Other Regulations - Regulation No. 10 (Electromagnetic compatibility)

Proposal for a Supplement to the 05 series of amendments to Regulation No. 10 (Electromagnetic compatibility)

Submitted by the expert from China*

Figure 1
Vehicle reference point

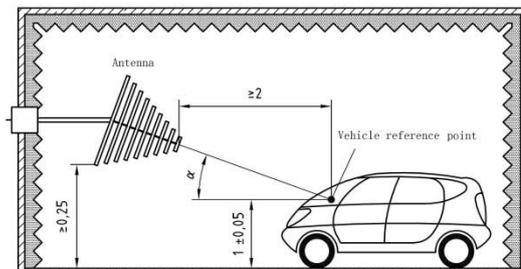
5. ISO 11451-2 prescribes two kinds of reference points, namely the facility reference point (line) and the vehicle reference point (line). They are different, as shown in Figures 1 and 2 below:

6. The calibration and actual measurement are based on the vehicle reference point. The use of the reference point can lead to the following problems:
- (a) The antenna is close to the vehicle, so the reflection of vehicle body will affect the antenna's radiation efficiency.
 - (b) The antenna is close to the control unit located in the front part of the vehicle, so as to increase the difficulty of the test.
7. For L category vehicles, Annex 6, paragraph 3.3. clearly defines a reference point. For a single probe calibration method, it should be described separately.
-

~~For TLS one field probe at the facility reference point shall be used.~~

For antennas one field probe at the vehicle reference point shall be used for category L vehicles.

~~For antennas four field probes at the facility-vehicle reference line shall be used for categories M, N, O vehicles."~~
